Vermont Agency of Transportation
RECEIVED
CK'D BY RK/GL OK'D BY WL
February 19, 2015
RESUBMIT YES Rejected
BY KH DATE 3-5-2015

Project: HARTFORD LATERAL BRIDGE
I-91 NORTHBOUND

Drawing: ABUTMENT 3 W/ WINGWALLS 5&6 REINFORCEMENT

Drawing: RETAINING WALLS
5-8 REINFORCEMENT

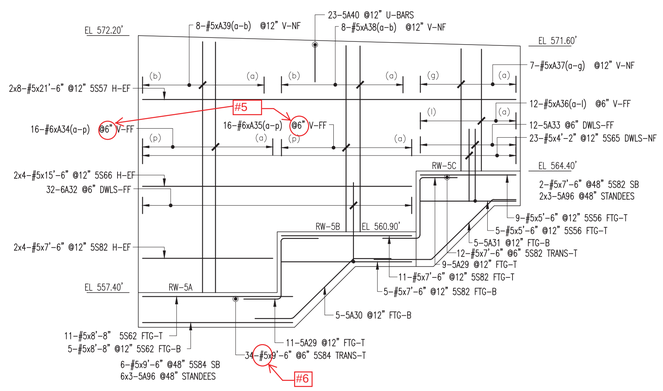
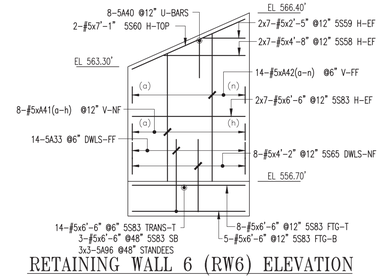
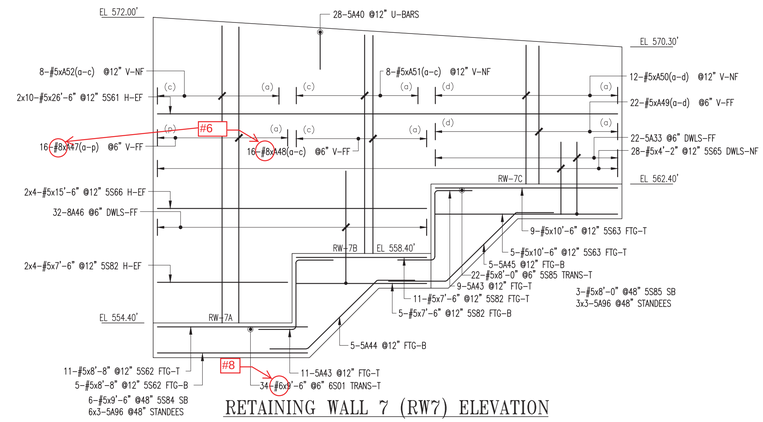
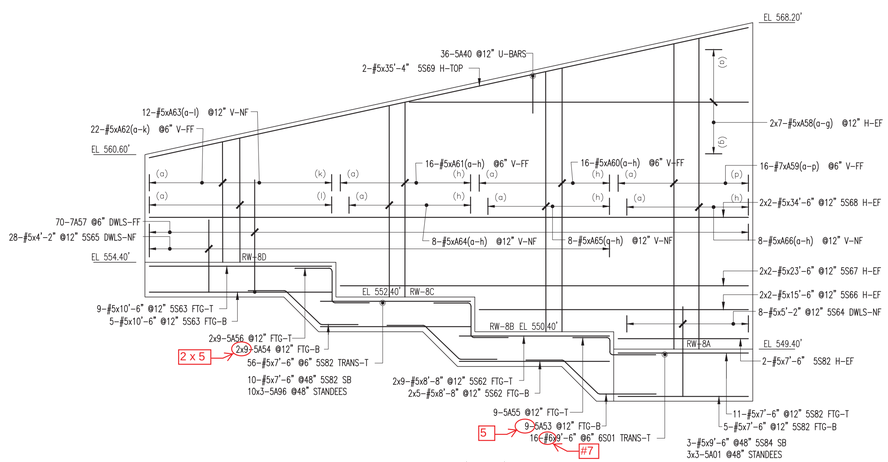
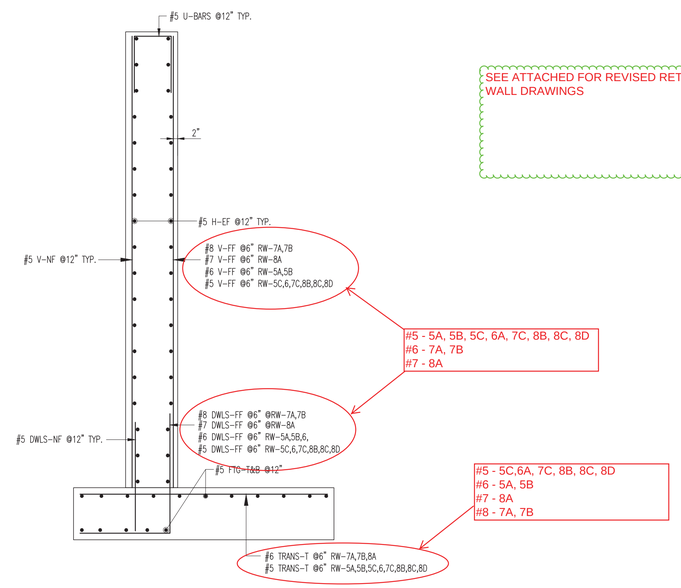
SEE ATTACHED FOR REVISED RETAINING WALL DRAWINGS

ABUTMENT 4 APPROACH SLAB

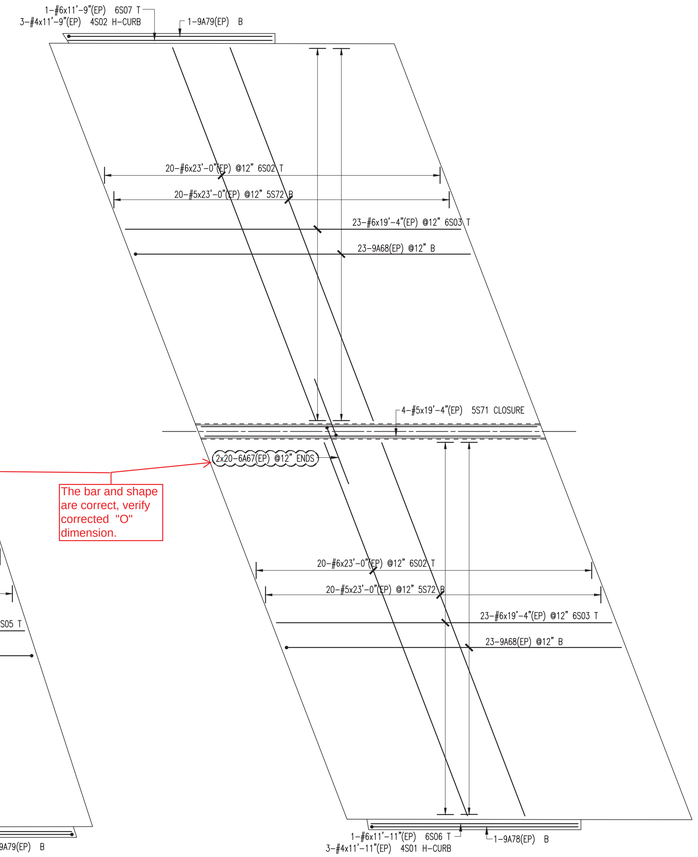
The bar and shape are correct, verify corrected "O" dimension.

ABUTMENT 3 SUSPENDED BACKWALL

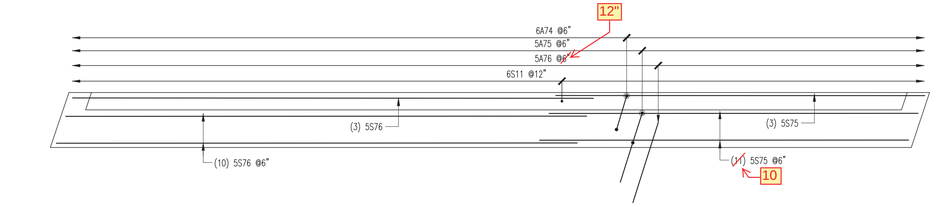
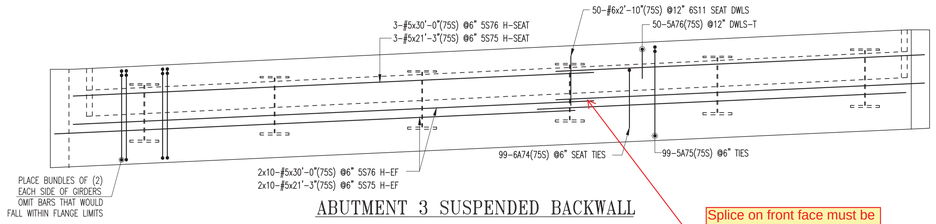
Splice on front face must be between girders. Holes in girder webs are not sized to accommodate splice.

SPECIAL BEND DETAILS

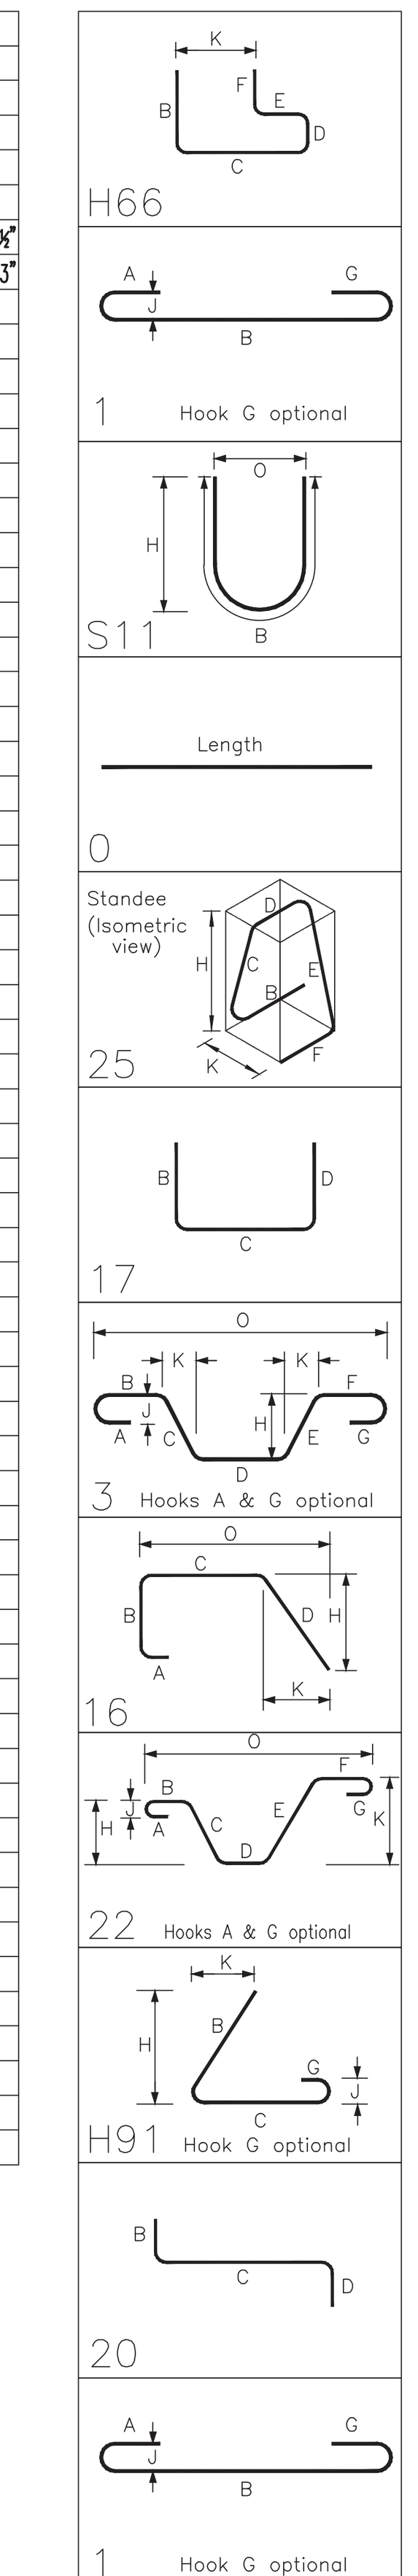
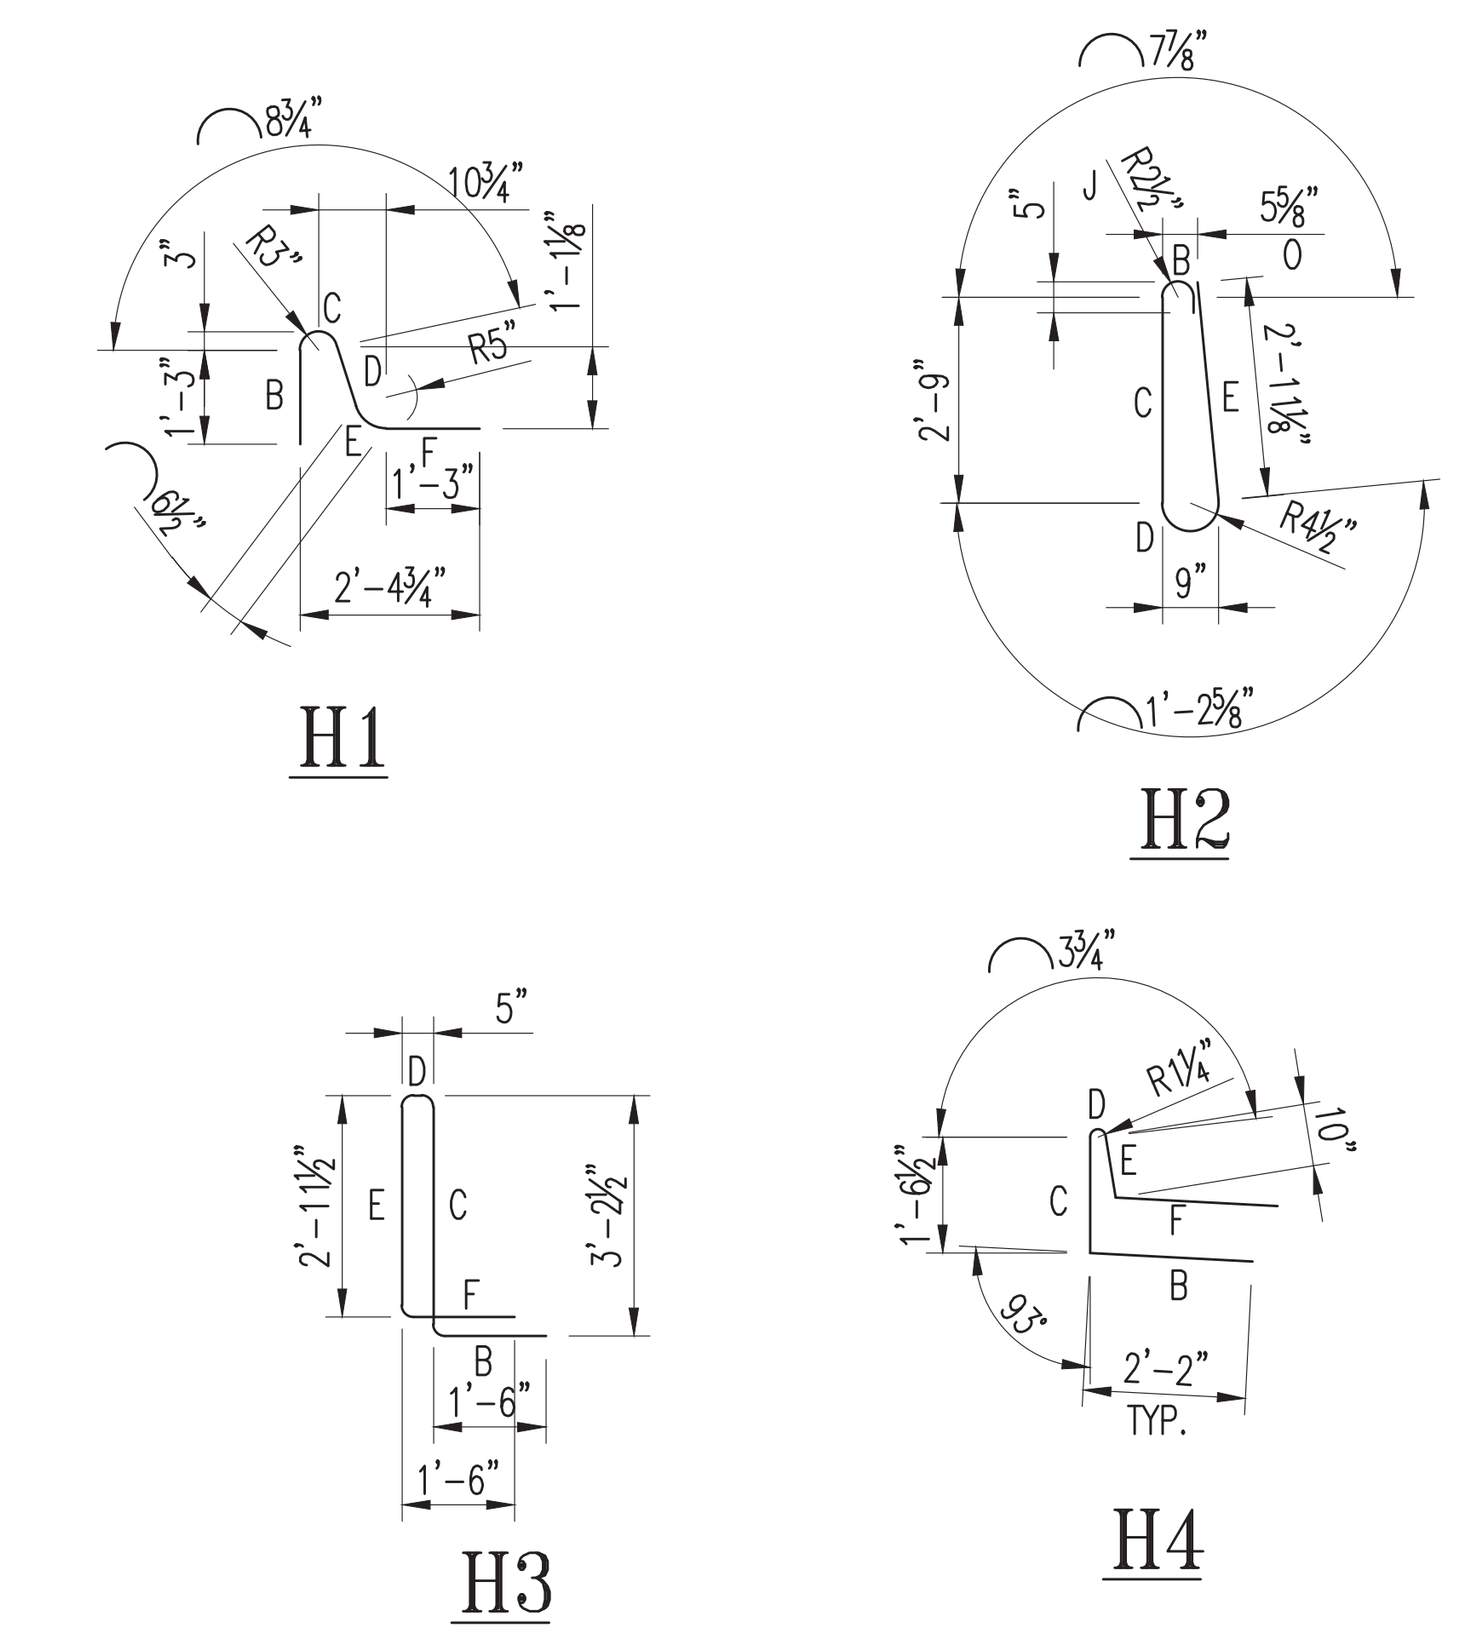
7.125" will match SB.

THIS NOTE APPLIES TO 43N AND THE PREVIOUSLY RETURNED 43S SCHEDULE.
Ensure that test bars are provided in accordance with the "Vermont Agency of Transportation Material Sampling Manual", available on the Agency website. A minimum of one test bar for each 100,000 lbs/size/grade and type of reinforcement (coating) shall be provided for each superstructure; each abutment; the four precast approach slabs as a group; and, the retaining walls as a group for each bridge. See the manual for acceptable dimensions of test sections. All cost associated with providing bars for testing shall be included in each reinforcing steel item or precast unit, as appropriate.

Material/coating should be identified in bar lists.

FILE NAME: s12a132retwall.dgn
PROJECT LEADER: K. HIGGINS
DESIGNED BY: G. LAROCHE
RETAINING WALL #5

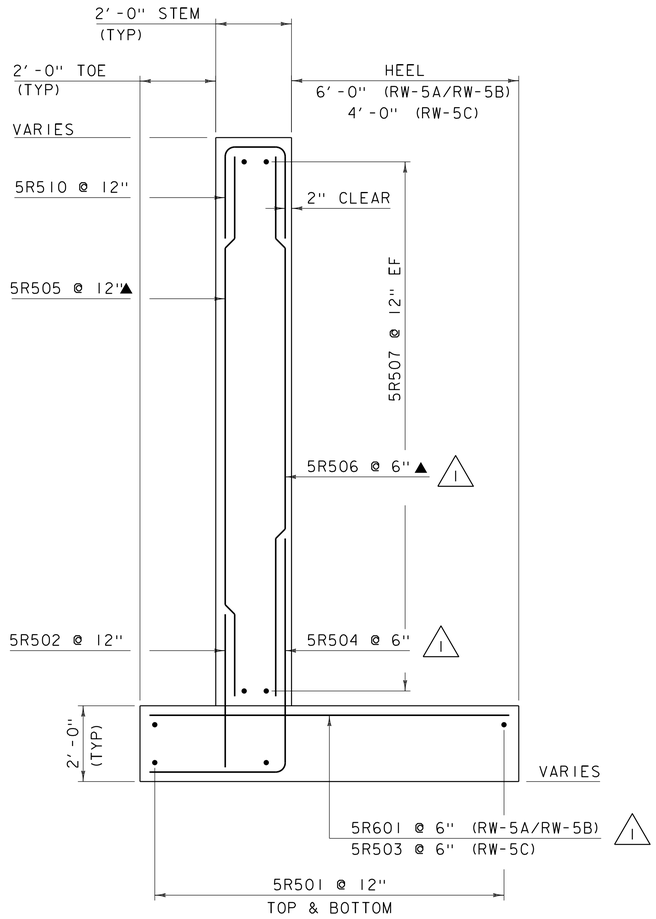
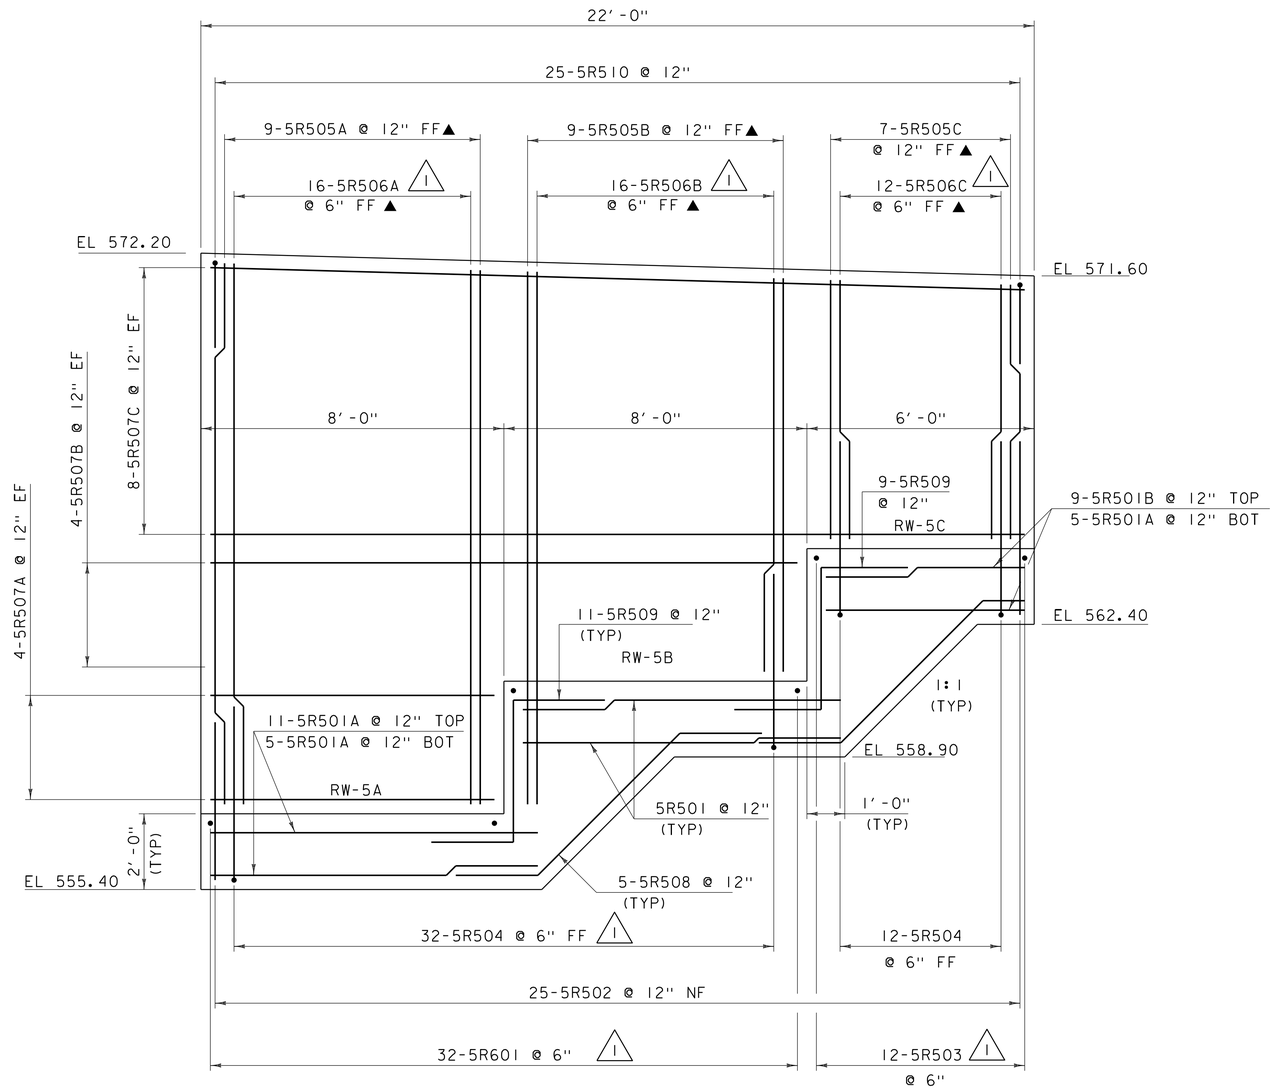
REVISION	DATE	DESCRIPTION	BY
1	03-05-2015	BAR CHANGES PER DESIGN	JS

FILE NAME: s12a132retwall.dgn
PROJECT LEADER: K. HIGGINS
DESIGNED BY: G. LAROCHE
RETAINING WALL #7

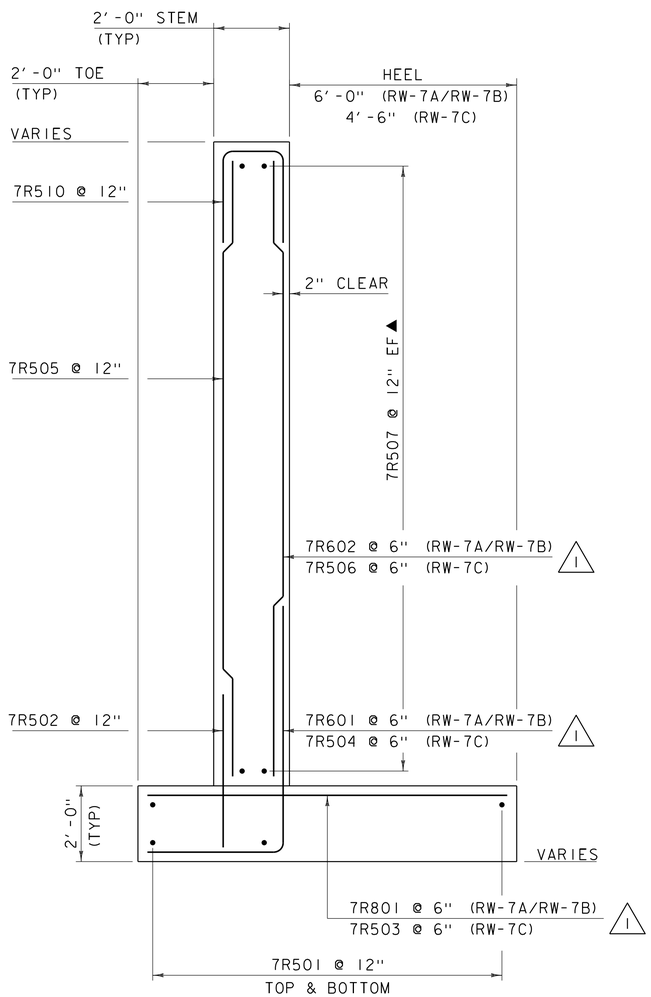
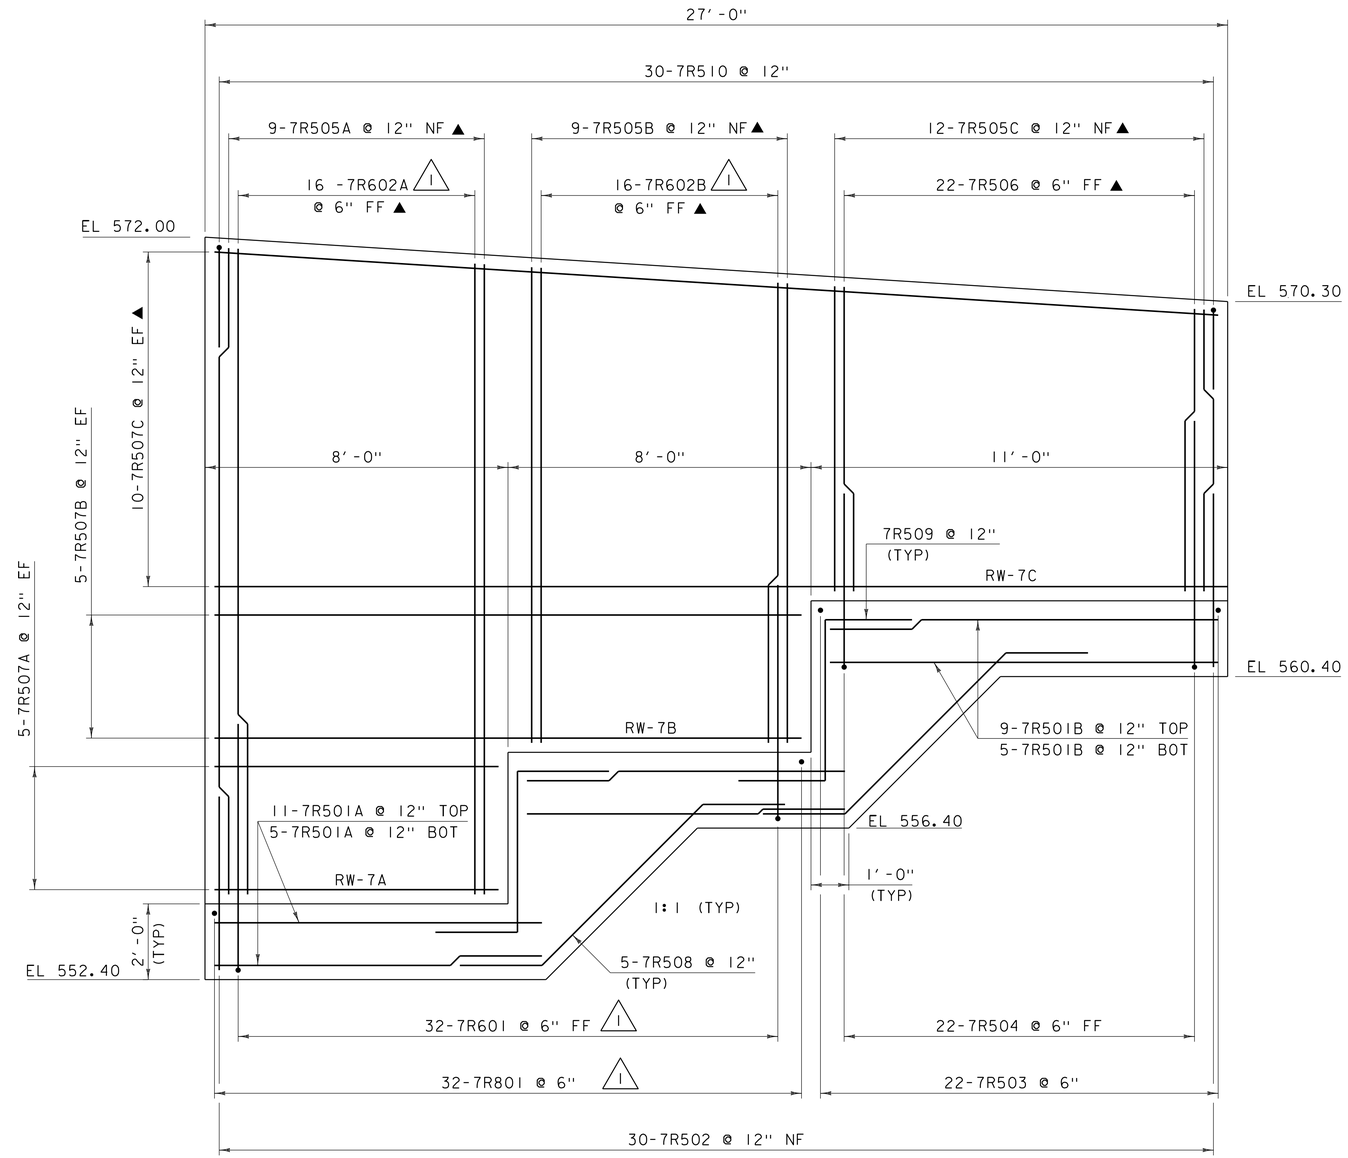
REVISION	DATE	DESCRIPTION	BY
1	03-05-2015	BAR CHANGES PER DESIGN	JS
